Section 4.55(1A) Modification Report

2-6 Hassall Street, Parramatta
SSD-9670 MOD 4 - WSU Innovation Hub

Submitted to Department of Planning, Industry
and Environment

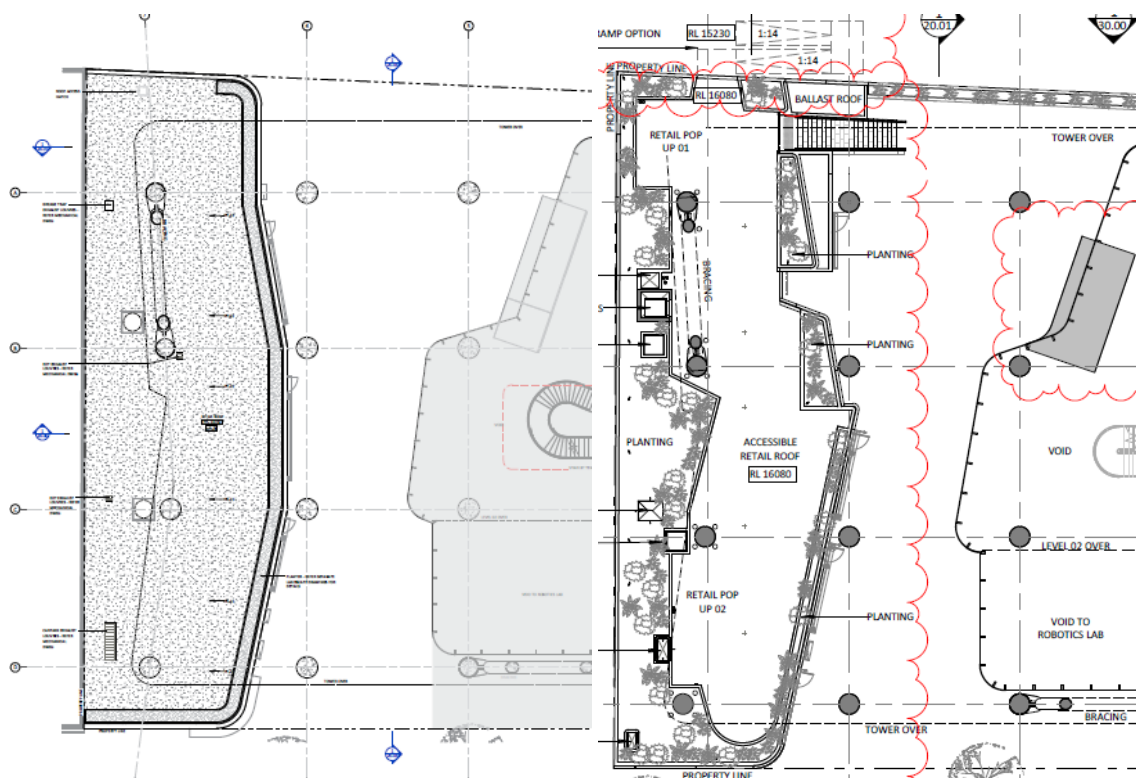
As a result of ongoing design development by the proponent and the project team, the Ground Floor retail building is proposed to be significantly enhanced and optimised. The result of the process is revisions to the layout and extent of the Ground Floor retail component set within the public domain space, with the primary driver behind the changes to facilitate access by the general public to a new rooftop space overlooking the building entry, amphitheatre, streetscape and the Lancer Barracks.

The proposal necessitates slight amendments to the retail tenancy layouts, amenities and back-of-house spaces such as end-of-trip facilities, which will enable the introduction of a new lift servicing Level 1 and to incorporate stair access at the northern end of the public domain. Corresponding changes include revisions to the landscaping design and the previously approved decked seating area adjacent to the northern boundary.

3D visualisations of the proposed Level 1 retail rooftop design viewed in both a northerly and southerly direction are illustrated at **Figures 1** and **2**. A comparison of the approved design and the proposed design is provided at **Figures 3** and **4**.

Figure 6 Proposed Section showing potential future connection to Lancer Barracks

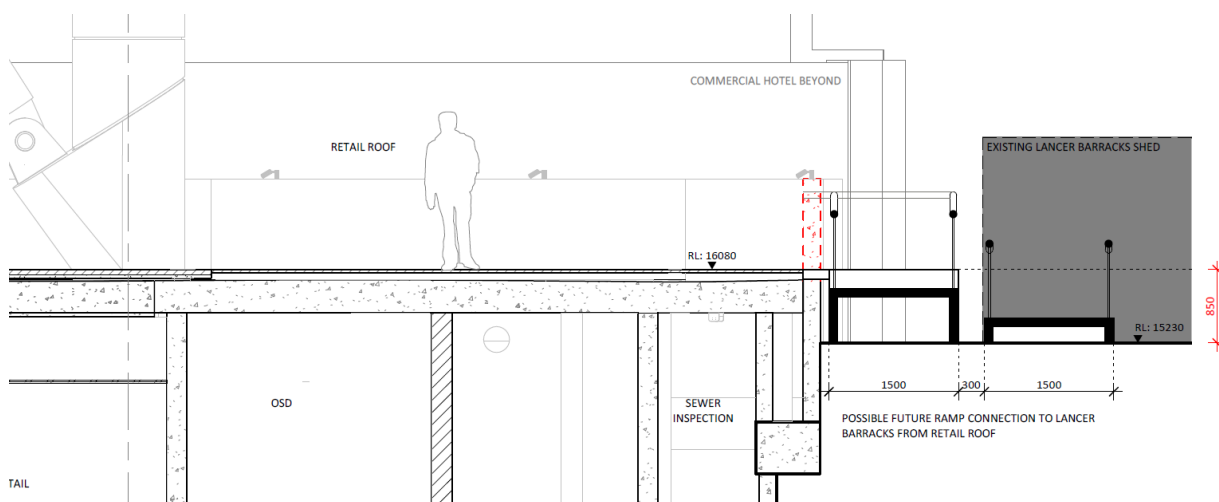
The proposed designs takes into consideration the 850mm height difference between the retail roof and Lancer Barracks. This level change has the potential to be altered in future through the installation of a ramp to ensure a complaint continuous accessible path of travel between the two sites when required in the future. Refer to the Architectural Plans at **Appendix A** and Design Report at **Appendix B** for further explanation. An extract of a section explaining the possible future integration of ramp access through to the Lancer Barracks is provided at **Figure 6**.
